SUBJECT: Campaign #91 S-Series Wire Cover/Accelerator Pedal Interference

**INSTRUCTION TO PERFORM CAMPAIGN #91**

**INSTRUCTIONS TO PERFORM CAMPAIGN #91**  
**Inspect/Reposition Driver Side Dash Wiring Shield**  
**on Vectra and Horizon Motorhomes built on Freightliner**  
**chassis with Cummins 400 diesel engine**

**Wiring Shield beneath driver side dash on S-series units (Vectra/Horizon)**

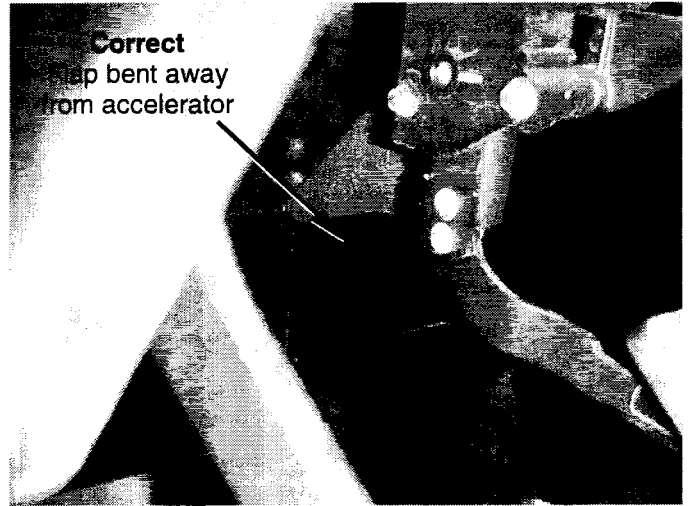
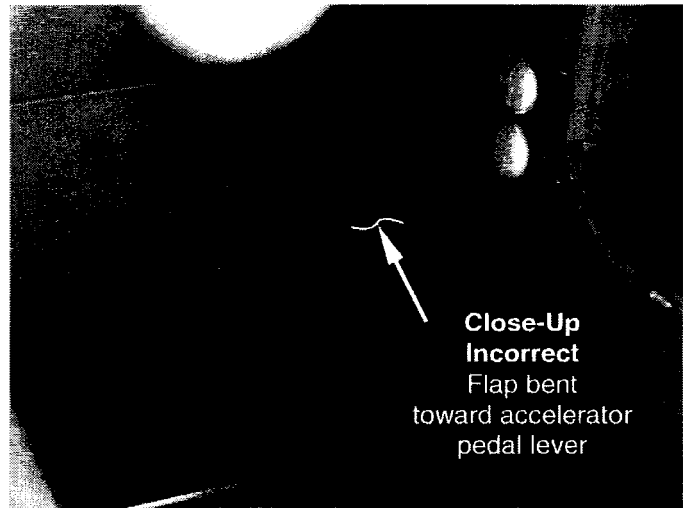
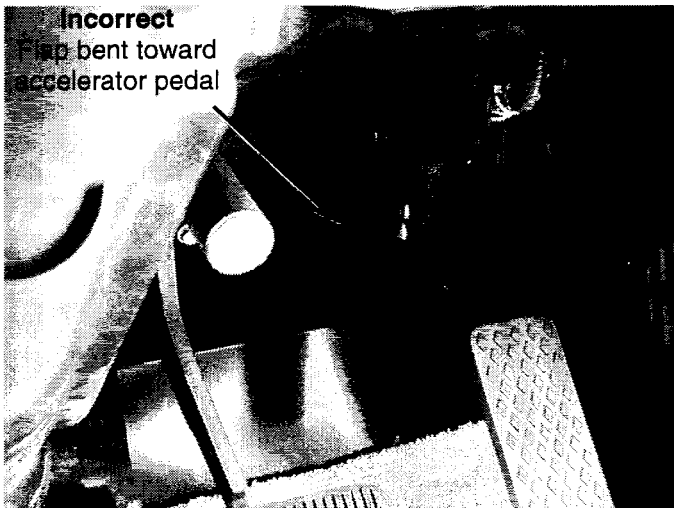
The basic procedure involves inspecting the dash wiring shield beneath the driver side of the dash and if necessary, bending the access flap forward by hand (away from accelerator linkage) to increase clearance for proper accelerator actuation.

See the following photos which show improper and proper orientation of the access flap on the wiring shield.

**Wiring shield beneath driver side of dash on Winnebago Vectra or Itasca Horizon)**

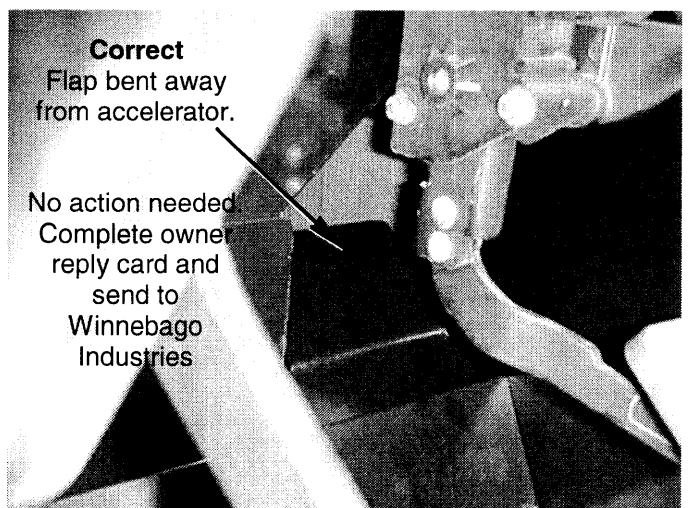
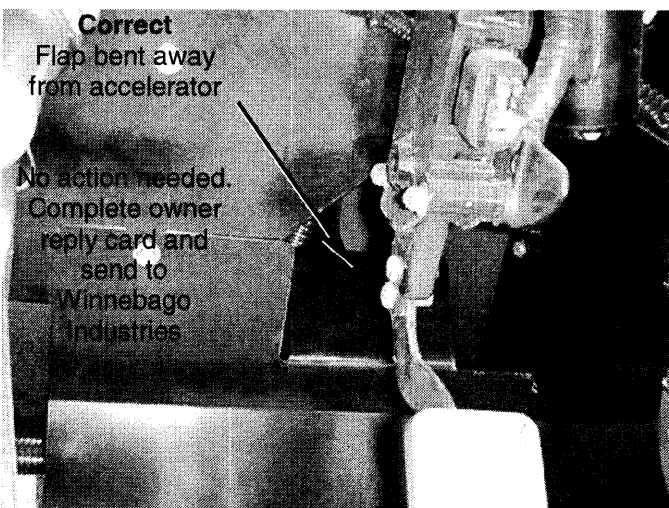
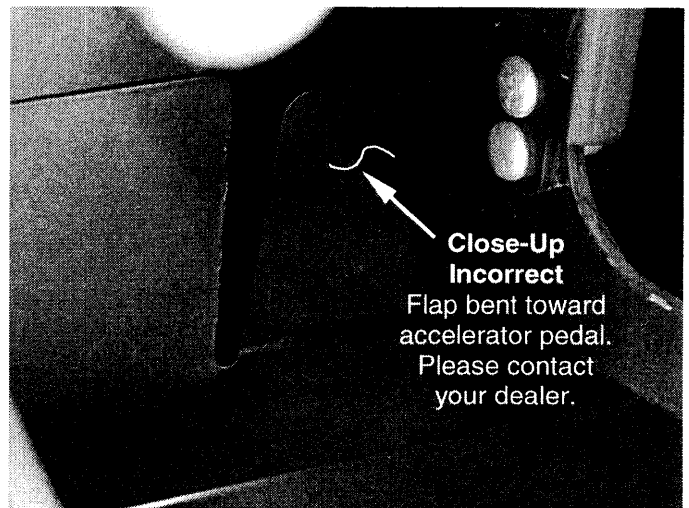
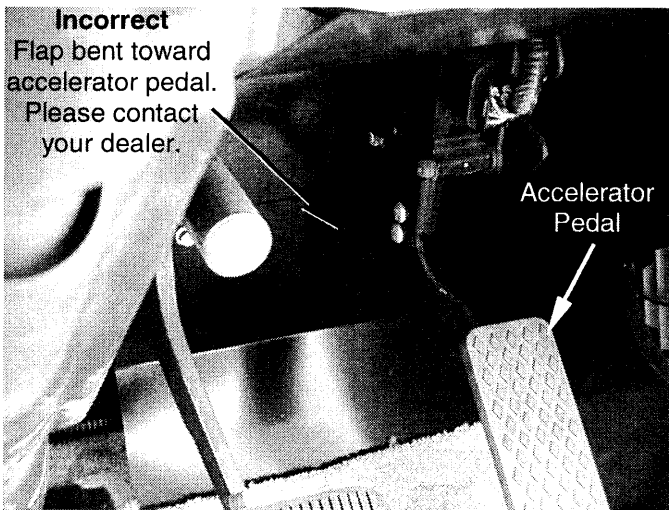
The basic procedure involves inspecting the dash wiring shield beneath the driver side of the dash. See the following photos which show improper and proper orientation of the access flap on the wiring shield. Please inspect the wire cover, then depending on condition, contact your dealer or complete the Owner Reply Card and send to Winnebago Industries as described in the photos below.
